UNITED STATES PATENT AND TRADEMARK OFFICE

APPLICATION NO.	FILING DATE	FIRST NAMED INVENTOR	ATTORNEY DOCKET NO.	CONFIRMATION NO.
09/777,681	02/07/2001	Kazuo Hakamata	Q61216	3338

Office Action Summary	Application No. 09/777,681	Applicant(s)  HAKAMATA, KAZUO	
	Examiner Shun Lee	Art Unit 2878

DETAILED ACTION

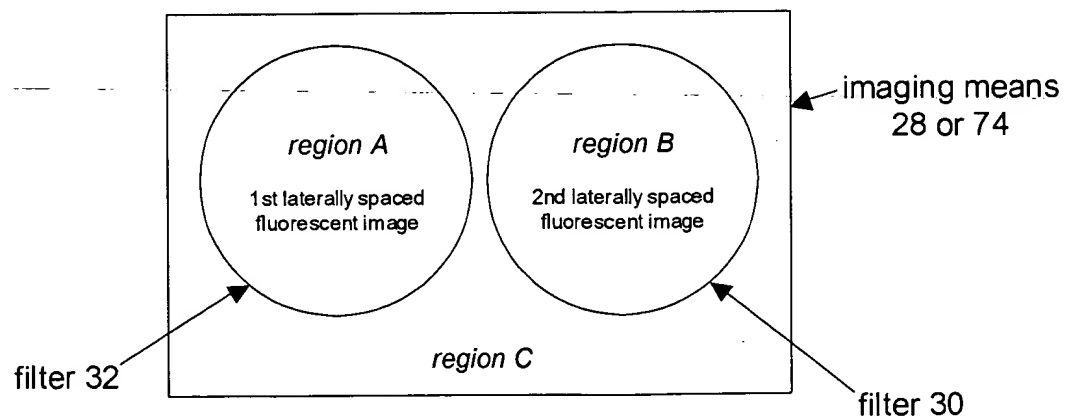
Applicant argues (last two paragraphs on pg. 3 of remarks filed 22 May 2003) that the spatially separate images of Lazarev *et al.* do not relate to different spaces such as an imaging region and a non-imaging region. Examiner respectfully disagrees. It should be noted that two regions of the imaging means are designated as a fluorescence imaging region and a non-imaging region. The fluorescence imaging region is utilized for the imaging of the fluorescence and the non-imaging region is a region other than the fluorescence imaging region, wherein the non-imaging region comprises a region where the fluorescence is not received. As discussed above, the scope of the claims encompasses a non-imaging region having a first region where the fluorescence is not received and a second region where the fluorescence is received. Thus region A and C (as illustrated above) can be designated as a non-imaging region (as defined in the claims) when region B (as illustrated above) is designated as a fluorescence imaging region.

Applicant than argues (second paragraph on pg. 4 of remarks filed 22 May 2003) designating only area 32 instead of areas 30 and 32 represents a shift in position that provides a tacit recognition that the prior analysis includes fundamental flaws. Examiner respectfully disagrees. As discussed above, the scope of the claims encompasses a non-imaging region having a first region where the fluorescence is not received and a second region where the fluorescence is received. Thus region C (as illustrated above) can be designated as a non-imaging region (as defined in the claims) when regions A and B (as illustrated above) are designated as a fluorescence imaging

Applicant further argues (last paragraph on pg. 4 of remarks filed 22 May 2003) that the non-imaging region cannot include two regions since the sensor obtains two fluorescent images. Examiner respectfully disagrees. As discussed above, the scope of the claims encompasses a non-imaging region having a first region where the fluorescence is not received and a second region where the fluorescence is received. Thus region C (and optional either region A or region B) can be designated as the non-imaging region (as defined in the claims).

Applicant argues (first paragraph on pg. 5 of remarks filed 22 May 2003) that Lazarev *et al.* teaches away from preventing reading of the non-imaging region since area 32 needs to be read in accordance with Eq. 2 of Lazarev *et al.* Examiner respectfully disagrees. As discussed above, the scope of the claims encompasses areas of the non-imaging region where the pixels are read. Since parts of the non-imaging region are read (e.g., area 32), it would have been obvious to one having ordinary skill in the art that unimportant pixels in the apparatus of Lazarev *et al.* are prevented from being read, in order to minimize the time consumed in reading

falling in region C illustrated above) in the invention of Lazarev *et al.* are *a priori* known as unimportant pixels since region C is defined by the filters 30 and 32 and it is regions A and B that contain the fluorescent images. Therefore, it would have been obvious to one having ordinary skill in the art that the *a priori* known unimportant pixels (e.g., pixels falling in region C illustrated above) in the apparatus of Lazarev *et al.* are prevented from being read, in order to minimize the time consumed in reading unimportant pixels as taught by Wilder *et al.*
